PRODUCT / PROCESS CHANGE NOTIFICATION
PCN-000774

For business continuity purposes, Semtech will start using qualified second-sources for assembly for the above-mentioned parts.

The assembly of these parts is currently performed at Carsem (Malaysia). Second-source assembly has been qualified at Greatek (Taiwan).

PCN No. 000774
Qualification of Greatek Taiwan for SX1280IMLTRT/
SX1281IMLTRT products

SEMTECH Package Outline on SX1250IMLTRT ASE (M) (Old) and Greatek (New)

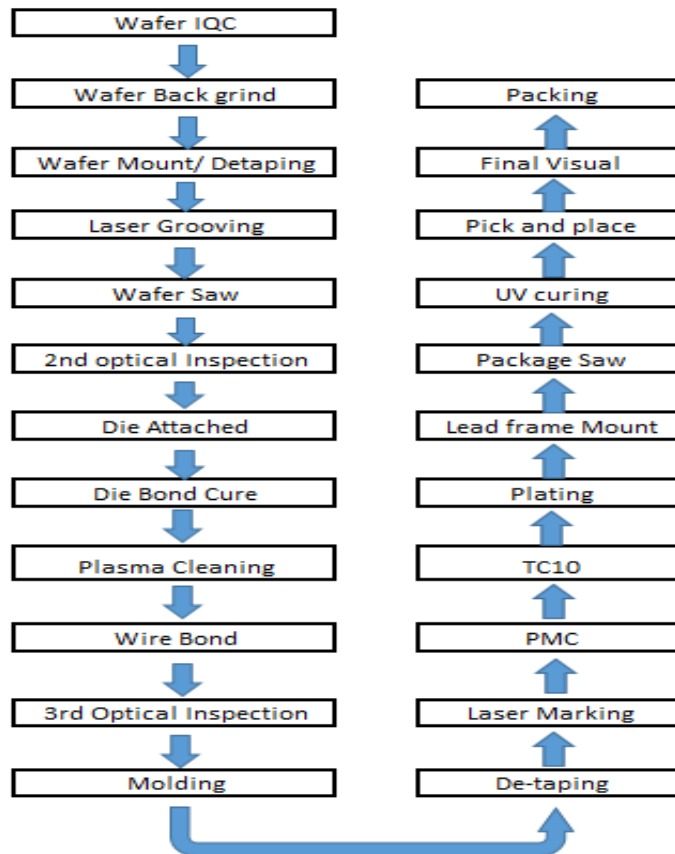
No Change in Package Outline.

Assembly Process Flow Comparison for ASE(M) (Old) vs. Greatek (New)

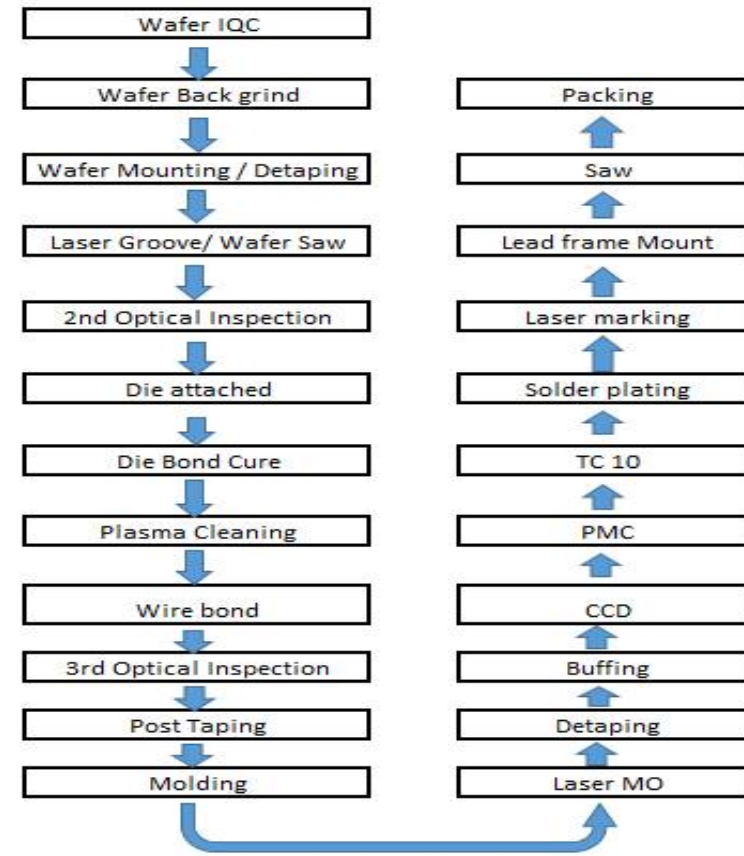
- No major Change in manufacturing Flow
- 100% TCT10 process step is applied in the assembly flow for both ASE(M) and Greatek.

Bonding Layout SX1280/ SX1281 (ASEM vs Greatek)

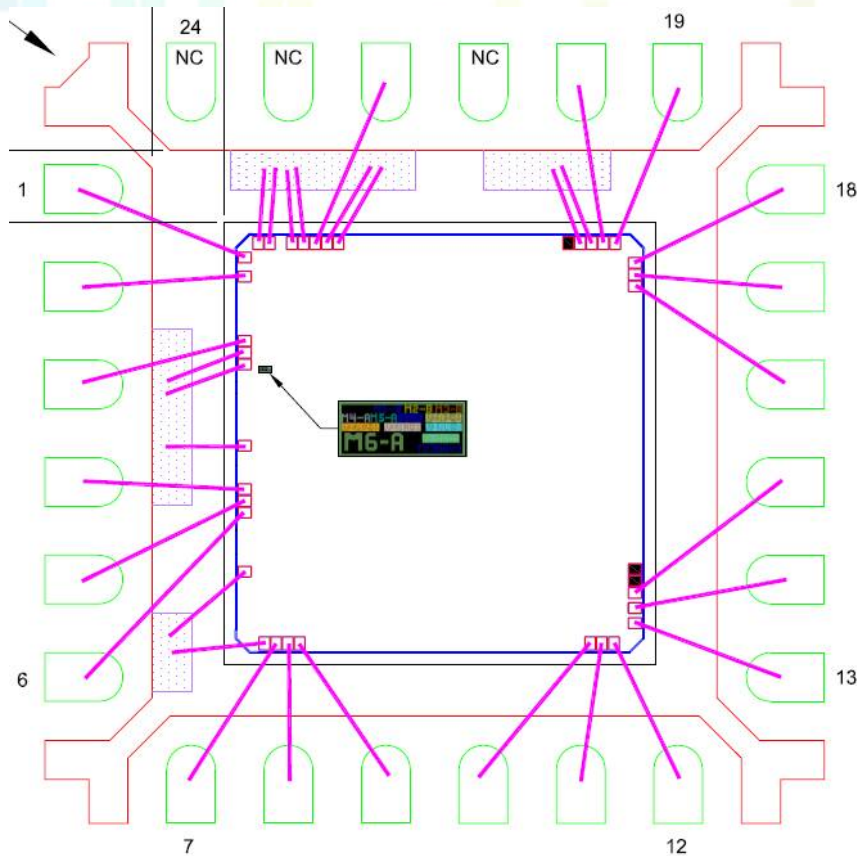
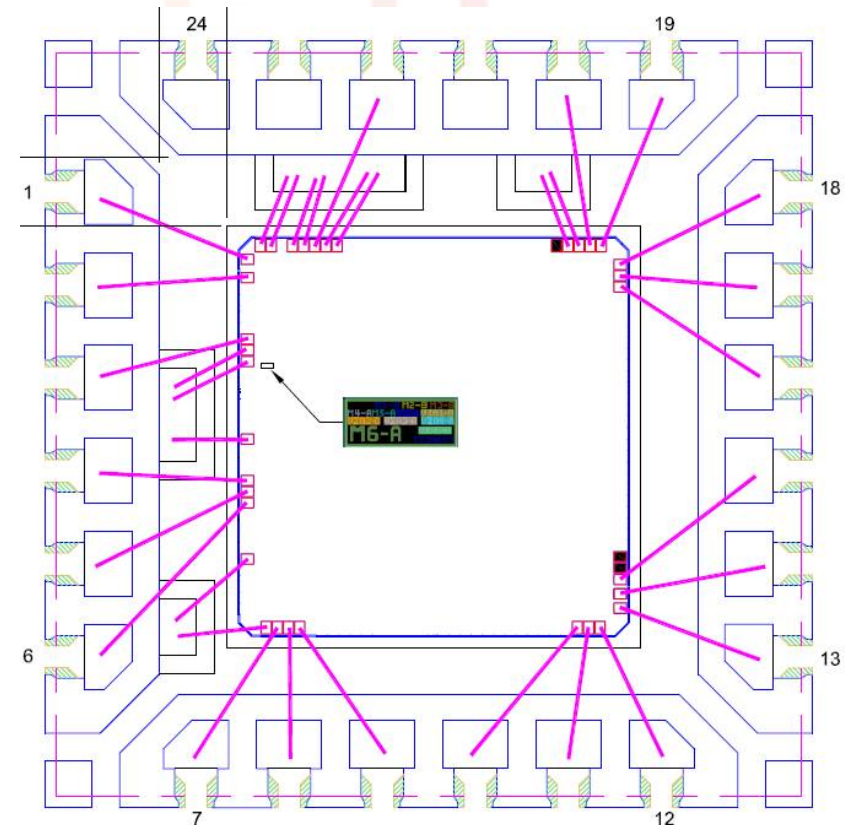
No Change in Bonding Layout.
